Sent: 18/03/2019 6:18:34 PM
Subject: Attn Nick England DA2019/0193 submission
Attachments: Submission Relating to DA at 21 Wattle Avenue 18 MARCH 2019 v1.0.pdf;

Submission Relating to the DA2018/1518

The following is a submission from 19 Wattle Avenue, Fairlight, related to the DA at the neighbouring property 21 Wattle Avenue, Fairlight.

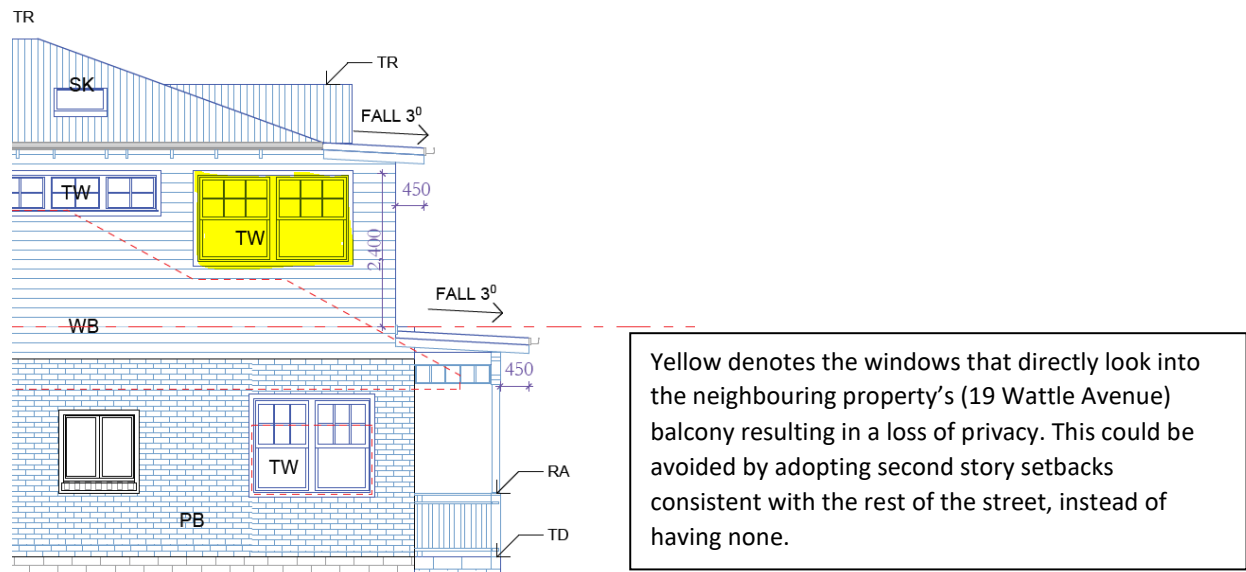
To maintain privacy, balconies on neighbouring properties in the street have been setback from the side-boundaries of at least 2m. This is to ensure balconies are not right next to each other and have enough separation.

Additionally, it does not follow the **DCP provision 4.1.4.2 (a)** that states; “Side setbacks and secondary street frontages a) Setbacks between any part of a building and the side boundary must not be less than one third of the height of the adjacent external wall of the proposed building.”

Provision **(b)** does not apply due to the loss of privacy. The balcony at the subject site would have only a 1.3m side setback. This will result in direct viewing from the balcony into the private open space of neighbouring property at 19 Wattle Avenue.

Shows second story setbacks of neighbouring properties (15, 17, 19).

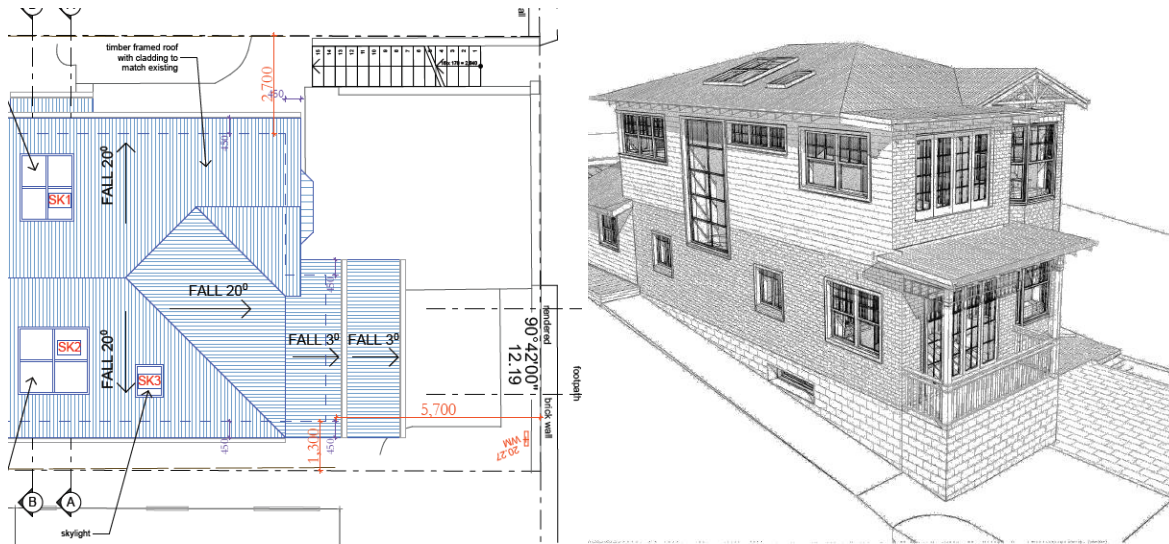
The windows of the 2nd storey north-eastern room (only setback 1.3m from the side boundary) on the second level would look directly into the balcony of neighbouring 19 Wattle Avenue. This could

be avoided by having an increased setback on the second storey, consistent with the other houses with second stories on this side of the street.

With side setbacks of 1.3m, the subject site proposed balcony does not consider DCP provision **3.4.2.2 Balconies and Terraces (b)** "Recessed design of balconies and terraces can also be used to limit overlooking and maintain privacy."

Shows height exceedance

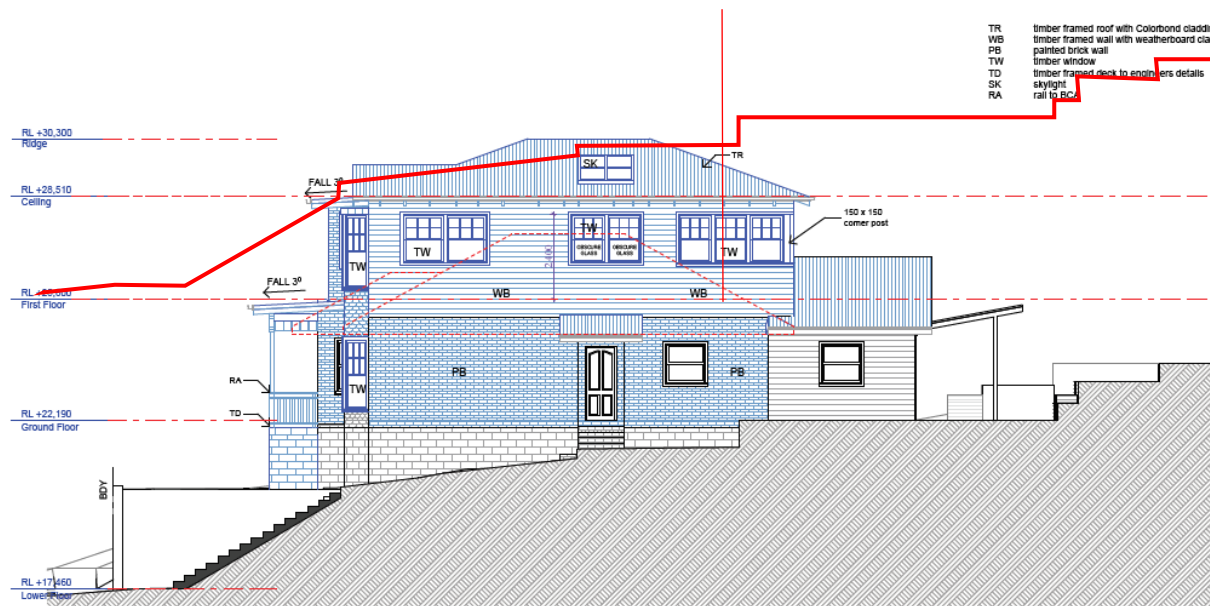
The proposed development will exceed the wall height requirement by up to 20%. Considering there are no side setbacks this is a very significant variation. This variation is calculated based on a two storey dwelling. This development is clearly a three storey development, with a storage area (and window) behind the garage and a rumpus room extending back to the stair well to provide internal access. This exacerbates the actual height of the proposed development.

Figure 2: Measuring the height of a dwelling house.

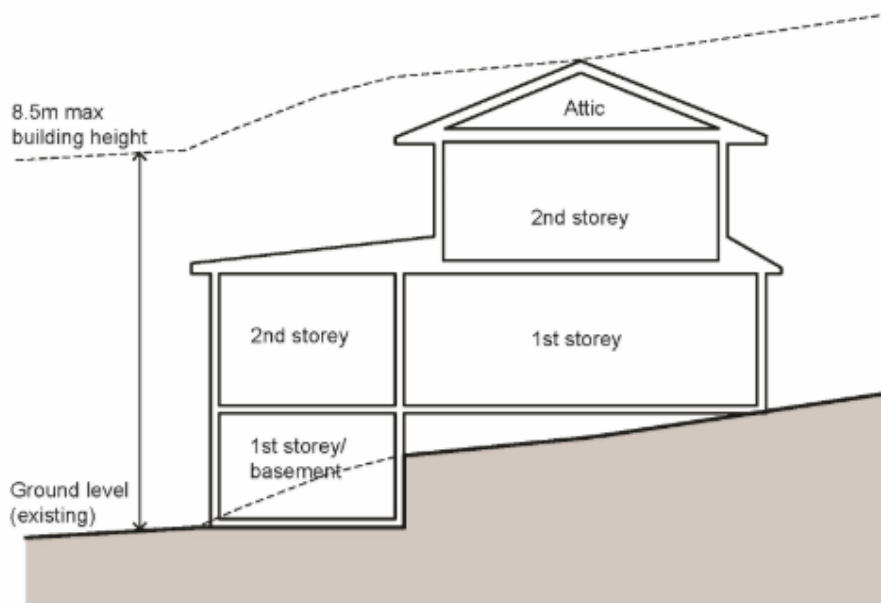
The above statement is false. The non-compliance is not a direct result of the slope of the site. 19 Wattle Avenue , Fairlight, the neighbouring property did not exceed the height limit despite the slope of the sight. If the proposal adopted the roof structure and second storey setbacks of neighbouring properties (in keeping with the streetscape) the proposal would be under the height control. Additionally, the image below (sourced from the Department of Planning and Environment’s website shows how height can be achieved and maximised on a sloping site.
